Point Beach Nuclear Plant, Units 1 and 2  
Dockets 50-266 and 50-301  
Renewed License Nos. DPR-24 and DPR-27

Response to Request for Additional Information  
License Amendment Request 247  
Spent Fuel Pool Storage Criticality Control

#### RESPONSE TO REQUEST FOR ADDITIONAL INFORMATION LICENSE AMENDMENT REQUEST 247 SPENT FUEL POOL STORAGE CRITICALITY CONTROL

**Figure 1 - Calculated  $k_{eff}$  (44-group Cross-Section Library) vs.  $H/^{235}U$**

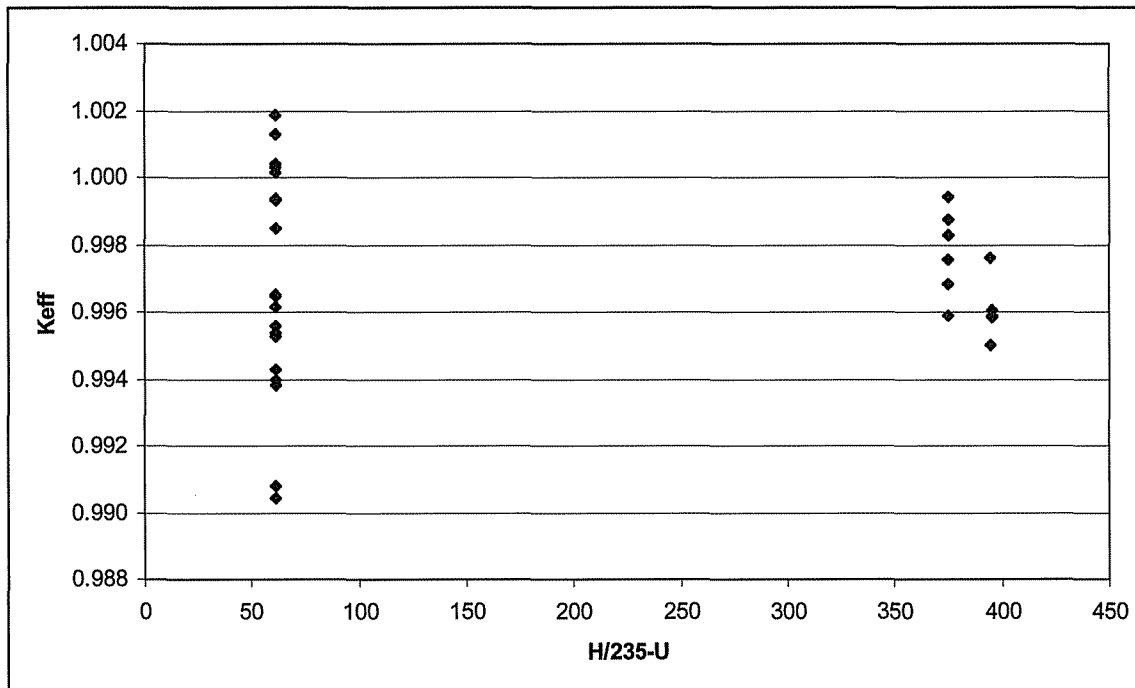
- a. Discuss and justify the method you used to select the benchmarks identified in Tables 1-1 and 1-2. For example, what parameters were considered to correlate the benchmarks to the systems being analyzed? What ranges were considered for those parameters?*
- b. Please provide additional details characterizing the benchmarks in terms of the parameters cited in Question 1a above, or submit References 9 through 12 of WCAP-16541-P, Revision 2. Currently, the submittal lacks sufficient information to evaluate the applicability of the benchmarks to the systems being analyzed.*
- c. Document and justify the area of applicability for the benchmarks.*
- d. Describe and justify any statistical and trending analyses performed to support the determination of the bias and bias uncertainty.*
- e. How did you account for the measurement uncertainties for the benchmarks?*

The calculated  $k_{eff}$ , using the 44-group cross-section library, of each of the thirty benchmark experiments was plotted versus the  $H/^{235}U$  value of the experiment, and is shown in Figure 1.

The data is well distributed and no trend is apparent as a function of  $H/^{235}U$ . The results using the 238-group cross-section library showed similar distributions.

Figure 3 -  $\Delta k$  in the All-Cell Configuration

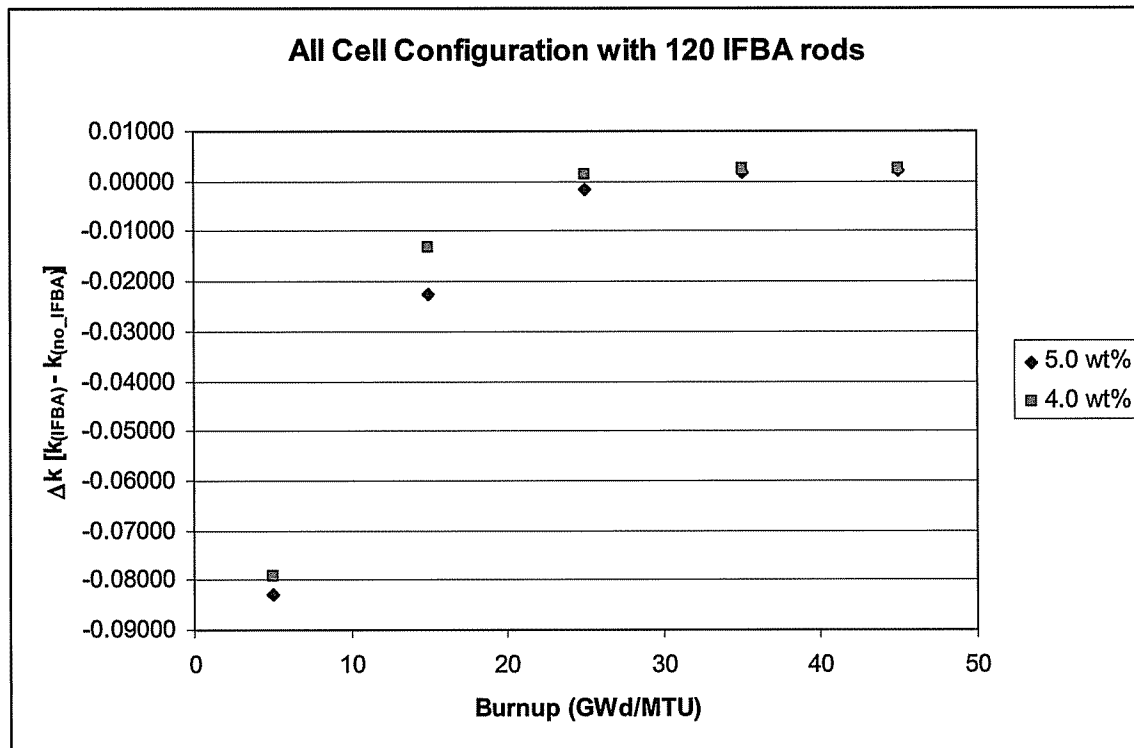
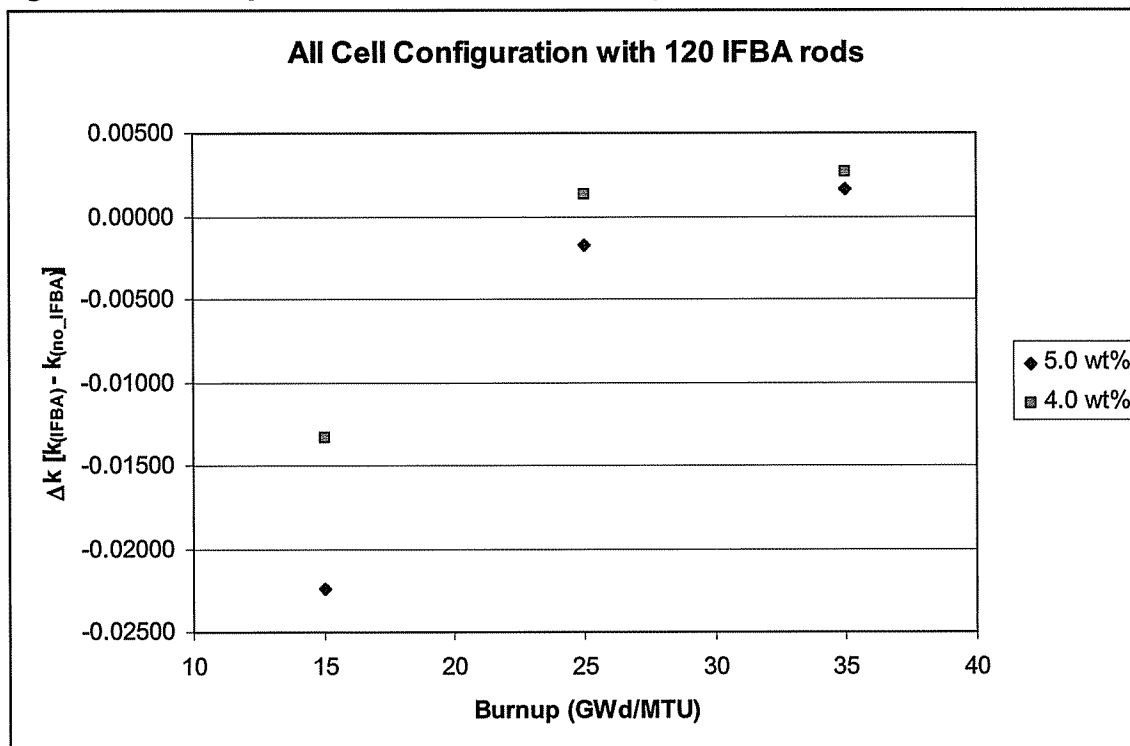
- a) *Letter dated September 19, 2008 (ADAMS Accession No. ML082630114), provided a response to the staff acceptance review. You state in response to Question 4, that the "results demonstrate that including the residual  $^{10}\text{B}$  provides sufficient reactivity margin to account for the spectral hardening caused by the presence of IFBA during the depletion." This statement conflicts with NUREG/CR-6760 which states that "... the  $\Delta k$  values become positive for fuel assembly designs containing IFBA rods but remain negative for gadolinia-bearing fuel assembly designs." NUREG/CR-6760 further states that "... analyses show that there is a negative residual effect for gadolinia-bearing fuel but no such effect for fuel designs with IFBA rods." Please resolve the difference in conclusions between your analysis and that of NUREG/CR-6760.*

Some similar trends are seen between the two analyses. Figure 41 in Section 3 of NUREG/CR-6760 shows  $\Delta k$  values versus burnup for the 156 IFBA pattern, with varying <sup>235</sup>U enrichments. Table 8 below shows similar trends for the 120 IFBA pattern, with varying <sup>235</sup>U enrichments in the All-Cell configuration of the PBNP analysis. The values shown in this table are plotted in Figures 3 and 4.

The data was fit using a fifth order polynomial and the difference in eigenvalues was found for the All-Cell configuration burnup limits for 4.0 wt% and 5.0 wt%, reported in Table 4-1 of WCAP-16541-P, Revision 2. The difference in eigenvalues at the burnup limits is shown in Table 9. For this site specific analysis, at the burnup limits specified in WCAP-16541-P, Revision 2, the residual IFBA is enough to overcome the effect of spectral hardening. The results confirm that neglecting the presence of IFBA is conservative in the All-Cell storage configuration.
